Annex A

Responses-to-Comments Table

Revised Sewerage Impact Assessment

APPLICATION FOR PLANNING PERMISSION UNDER SECTION 16 OF THE TOWN PLANNING ORDINANCE (CAP. 131) FOR PROPOSED HOTEL USE AND MINOR RELAXATION OF PLOT RATIO RESTRICTION AT "OTHER SPECIFIED USES" ANNOTATED "BUSINESS (1)" ZONE AT NO. 646 - 648A CASTLE PEAK ROAD, CHEUNG SHA WAN, KOWLOON

Sewerage Catchment Plan

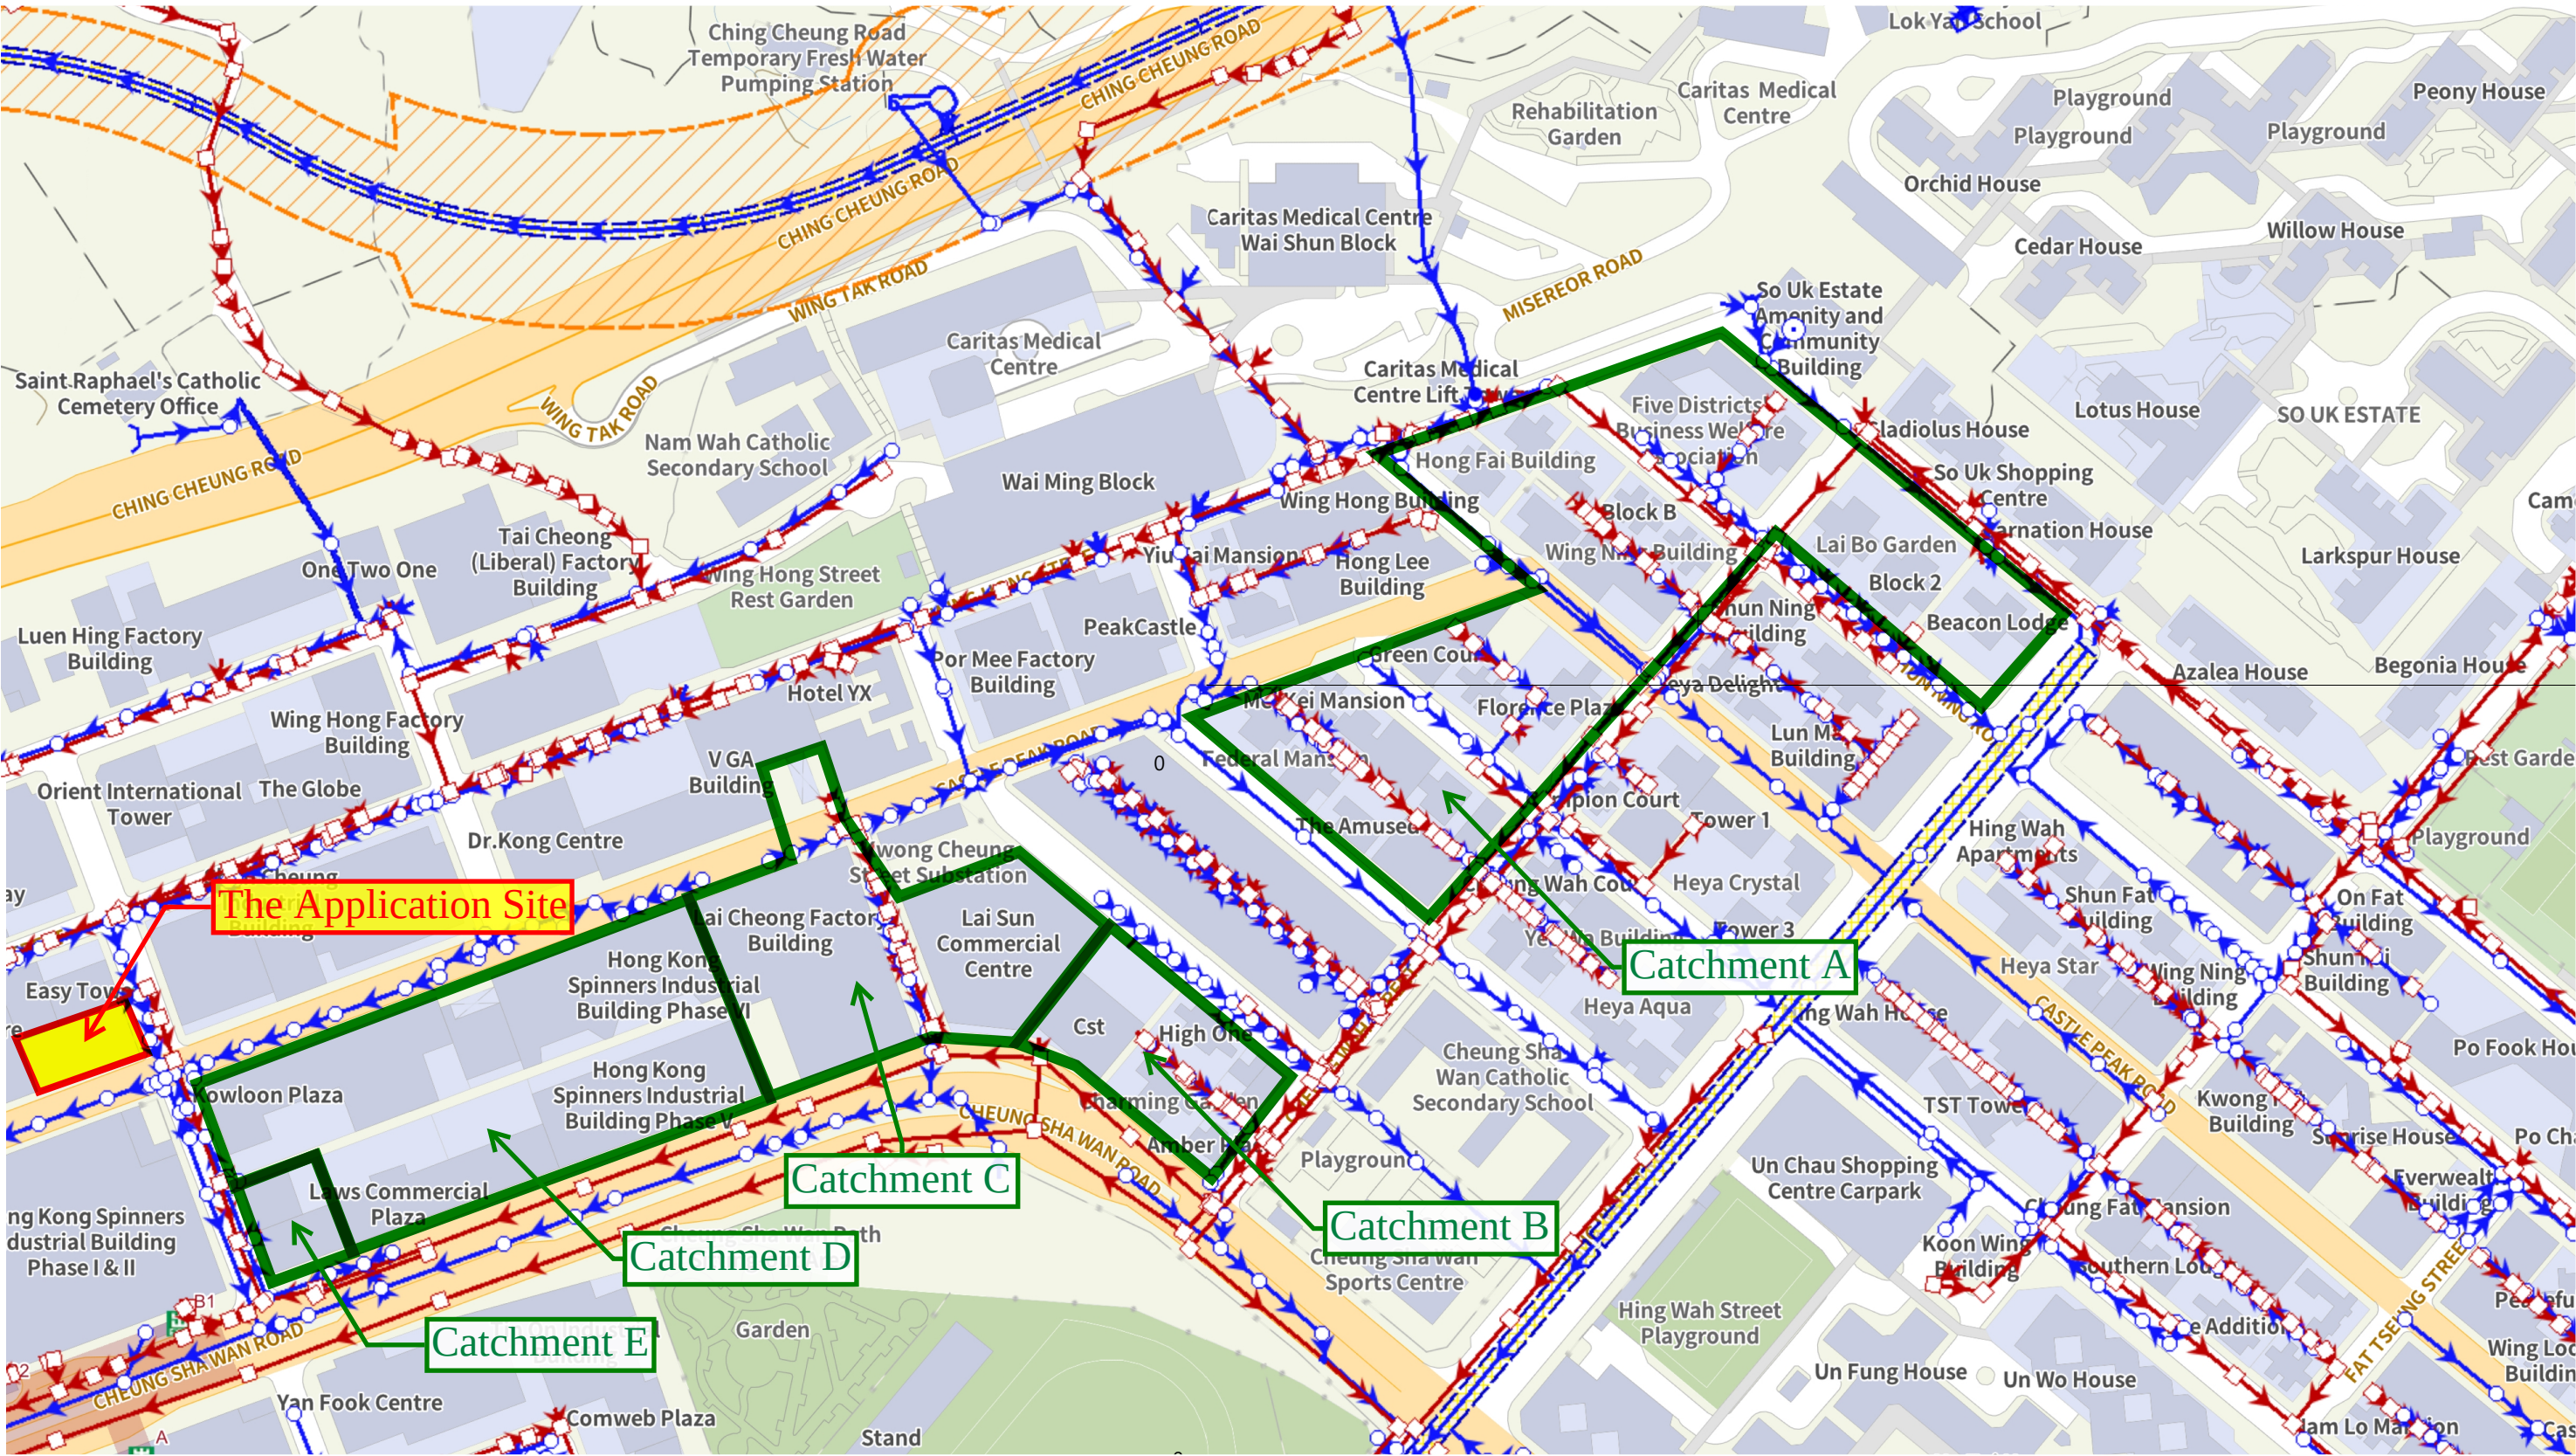
No.	Comments	Responses
	effective sewerage mitigation measure where appropriate. Appendix C (6) It appears that the GFA of existing developments in Catchment D were substantially reduced compared with the previous SIA submission. Please advise the relevant reference sources to justify the proposed changes. Appendix F (7) For “Capacity Performance of Existing Sewer (Freeboard Checking)”, it appears that the length of existing sewers had been updated compared with the previous SIA submission, leading to the changes of assessment results. Please advise the relevant reference sources to justify the proposed changes.	The relevant sources of information are supplemented. Please refer to the revised Appendix C of the SIA (Annex B refers). The changes are based on the GEOINFO MAP record. The record is supplemented in Appendix A –Sewerage Record. Please refer to the revised Appendix A of the SIA (Annex B refers).

Drawing Title
GROUND FLOOR PLAN

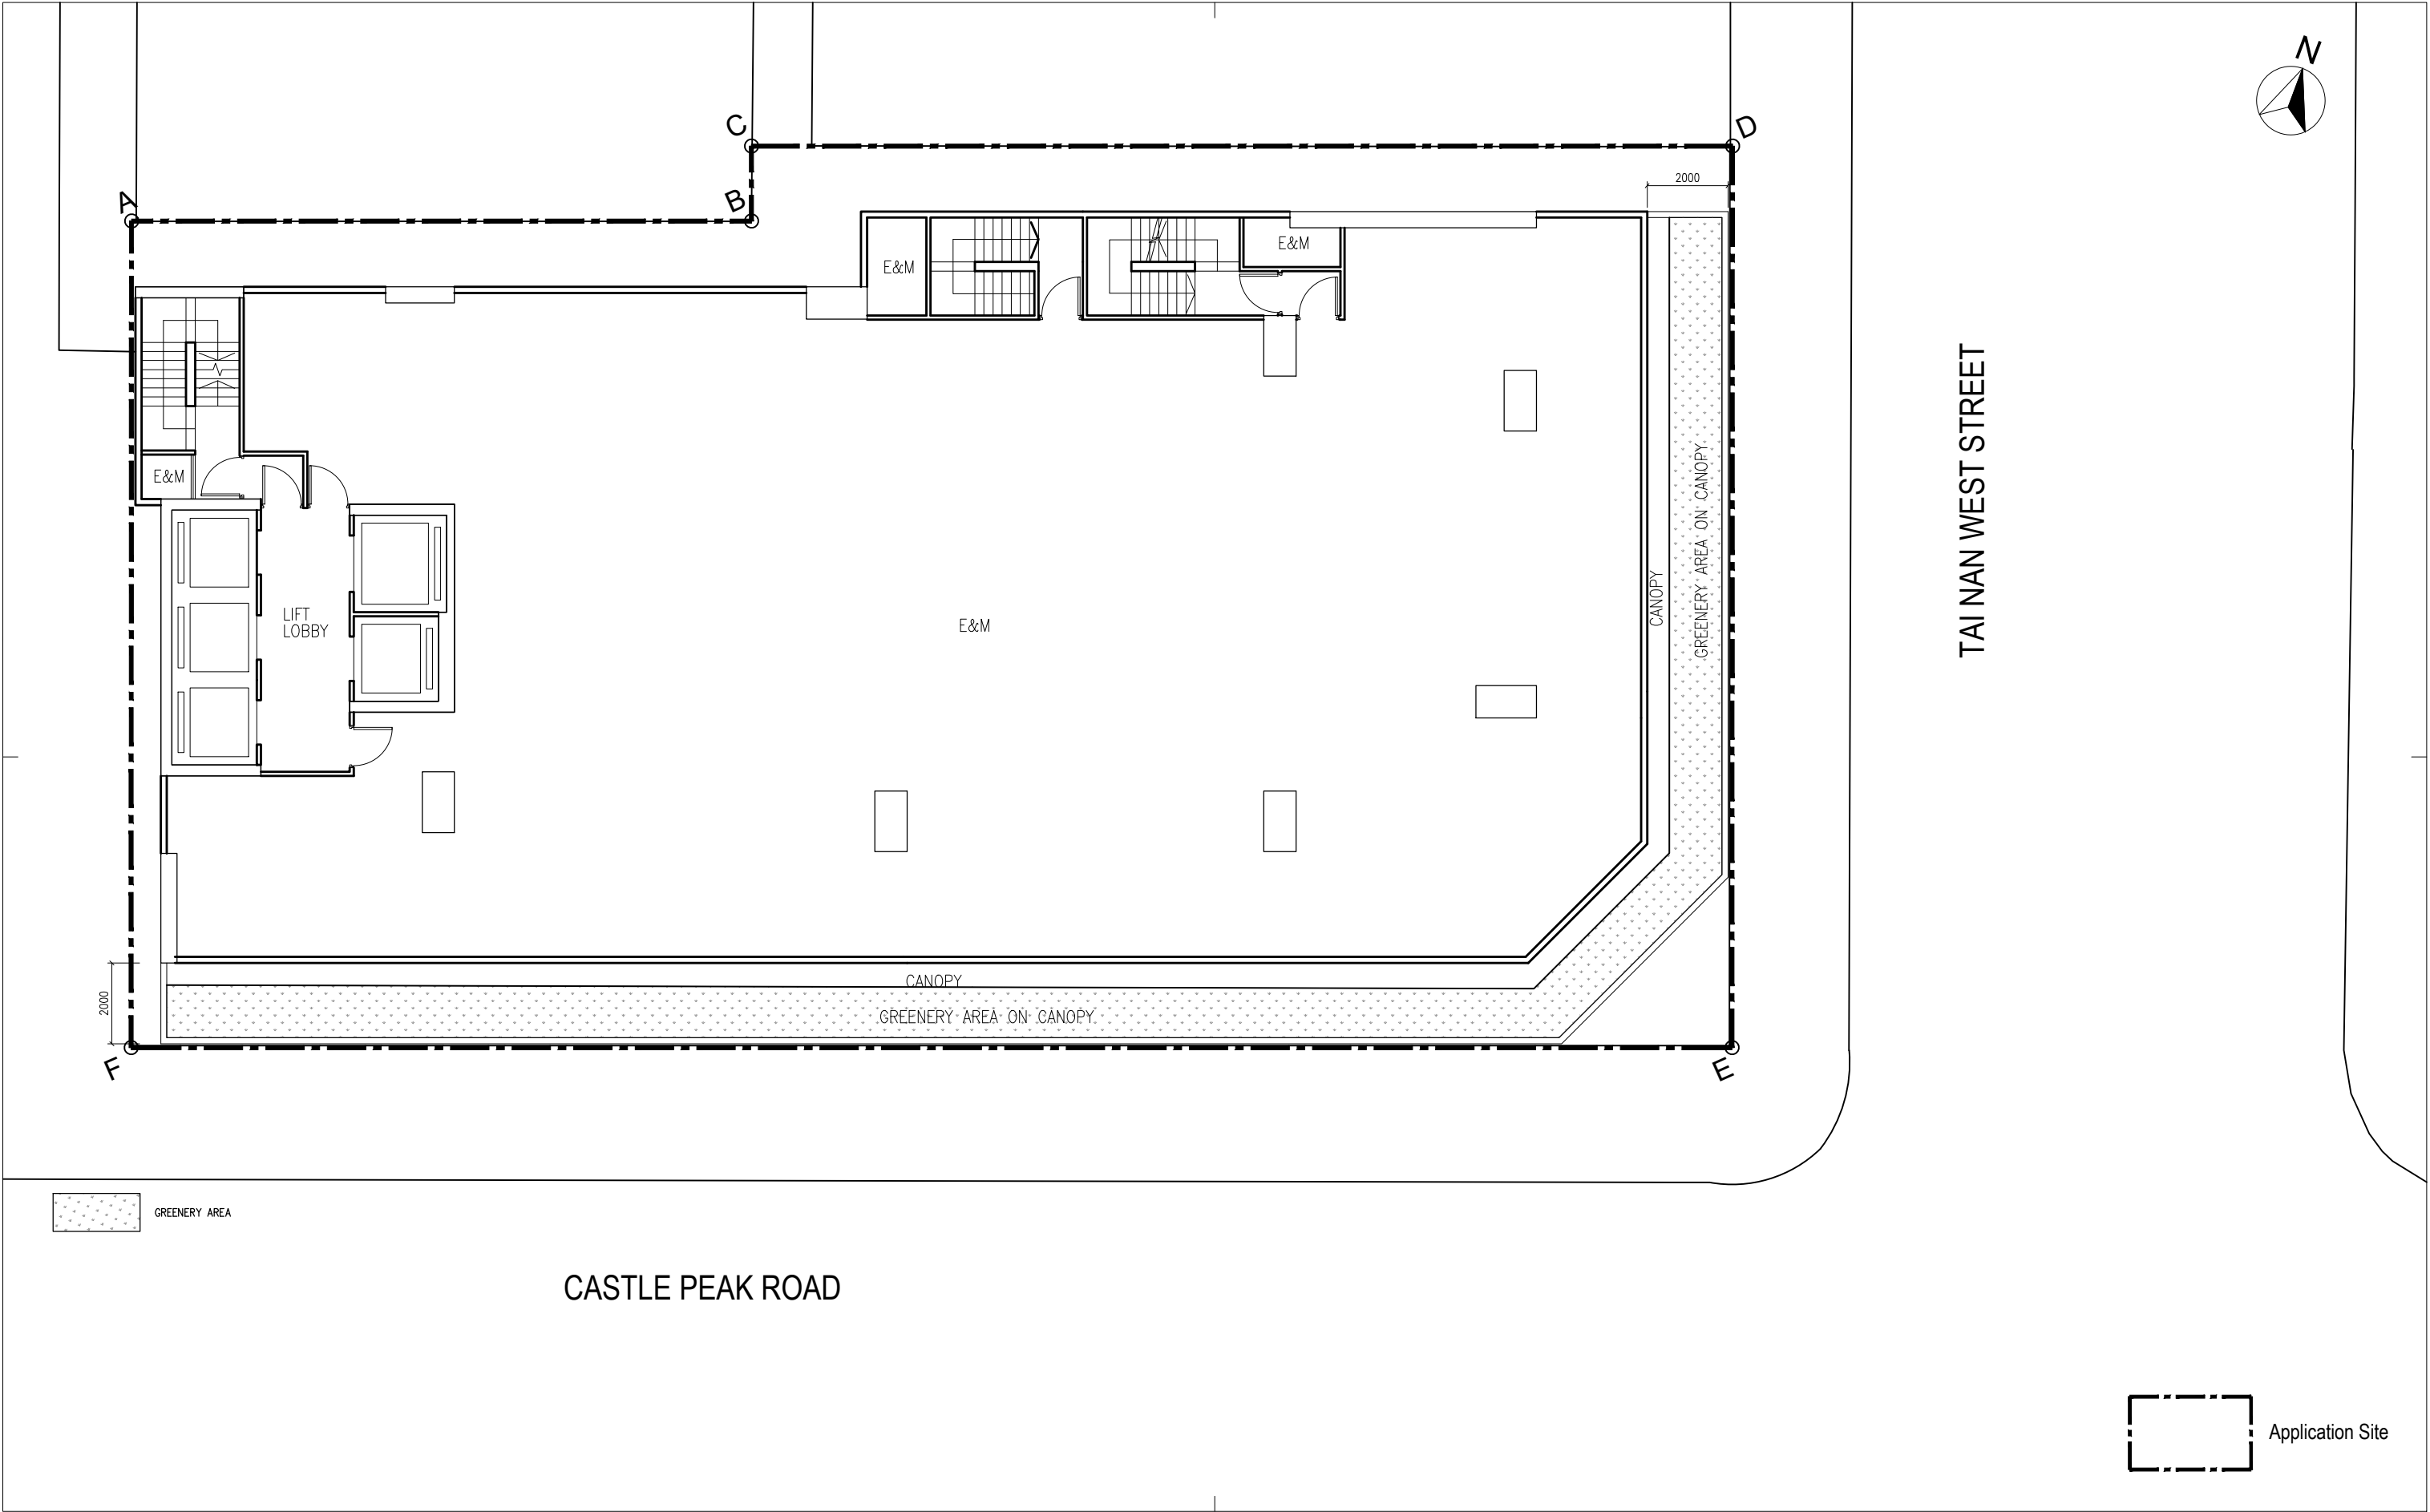
7. Ground Floor Plan – the current design of the greenery area may occupy part of the pedestrian circulation area. Reference can be made to the scheme for the previous s.16 application no. A/K5/838 especially on the location of the greenery area and walkable tree grille to revise the proposed greenery measures.	To enhance the pedestrian circulation and comfort, the ground floor greenery proposal has been refined, taking into account the comments received from relevant Government departments. Please refer to the revised Architectural Layout (Annex D refers)
